UNITED STATES
NUCLEAR REGULATORY COMMISSION
WASHINGTON, D. C. 20555

SUBJECT: AMENDMENTS NOS. 91 AND 84 TO FACILITY OPERATING LICENSES
NOS. DPR-42 AND DPR-60: TECHNICAL SPECIFICATION (TS) UPGRADE
(TAC NOS. 61081 AND 61082)

The Commission has issued the enclosed Amendments Nos. 91 and 84 to Facility Operating Licenses No. DPR-42 and DPR-60 for the Prairie Island Nuclear Generating Plant, Units Nos. 1 and 2. These amendments consist of changes to the Technical Specifications (TS) in response to your application dated March 17, 1986, and supplemented by letter dated July 27, 1987.

FIGURE IS.3.10-1

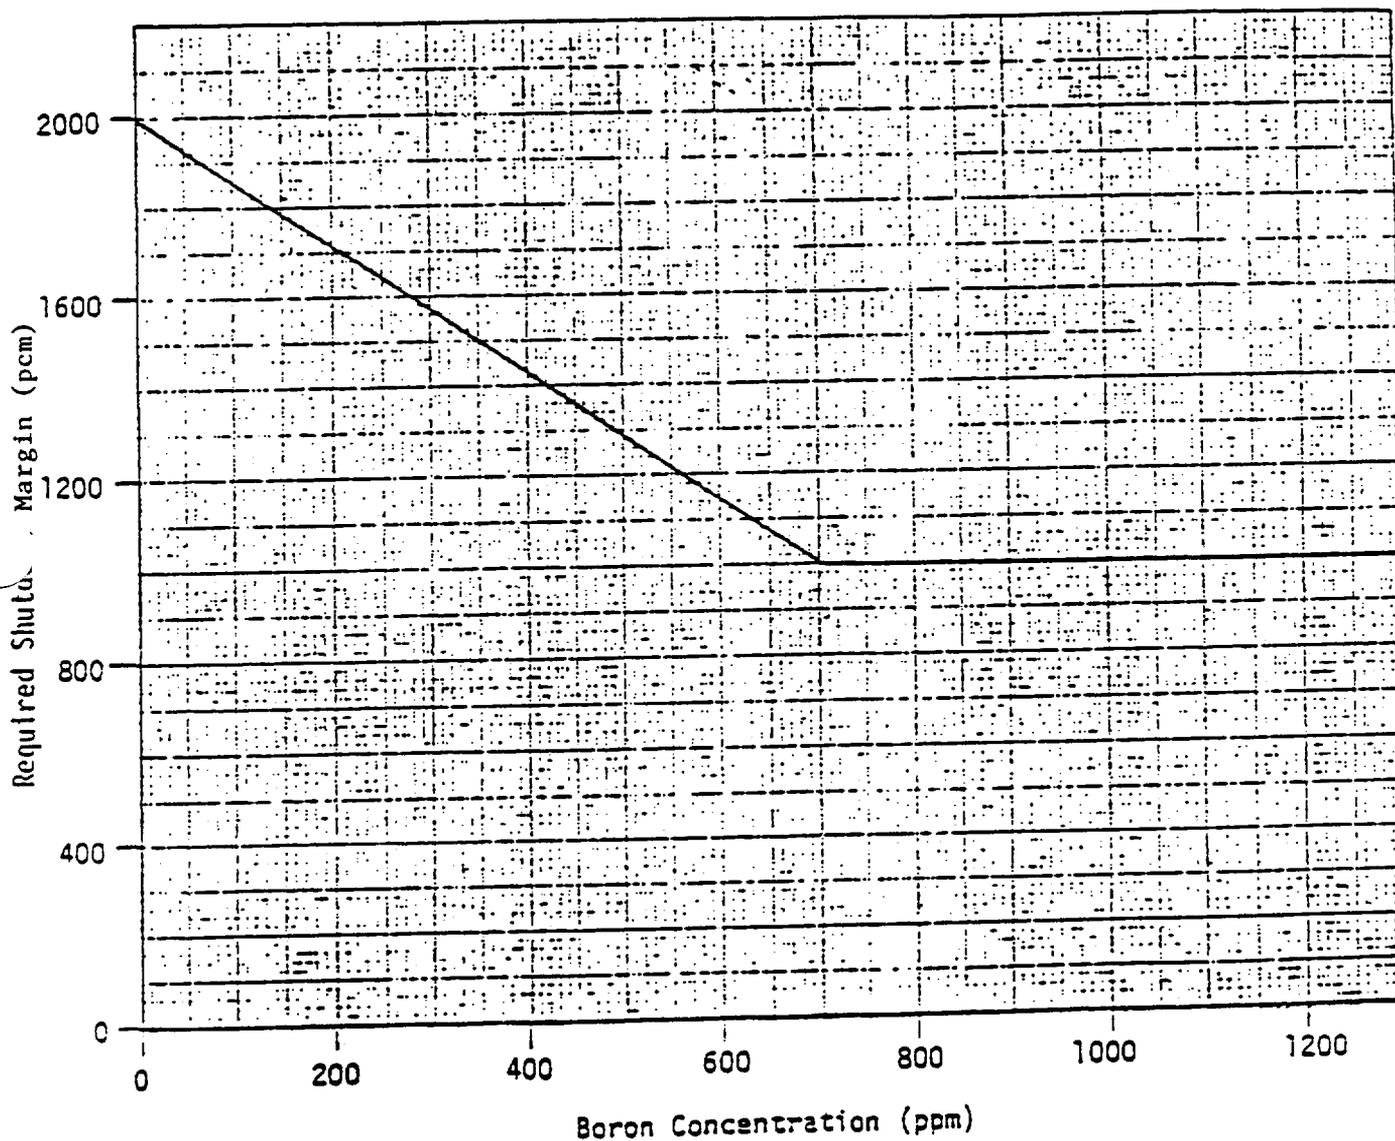
The shutdown margin with allowance for a stuck control rod assembly shall exceed the applicable value shown in Figure TS.3.10-1 under all steady-state operating conditions, except for PHYSICS TESTS, from zero to full power, including effects of axial power distribution. The shutdown margin as used here is defined as the amount by which the reactor core would be subcritical at HOT SHUTDOWN conditions if all control rod assemblies were tripped, assuming that the highest worth control rod assembly remained fully withdrawn, and assuming no changes in xenon or boron concentration.

4. Insertion limits do not apply during PHYSICS TESTS or during periodic exercise of individual rods. The shutdown margin shown in Figure TS.3.10-1 must be maintained except for low power PHYSICS TESTING. For this test the reactor may be critical with all but one high worth control rod inserted for a period not to exceed 2 hours per year provided a rod drop test is run on the high worth control rod prior to this particular low power PHYSICS TEST.
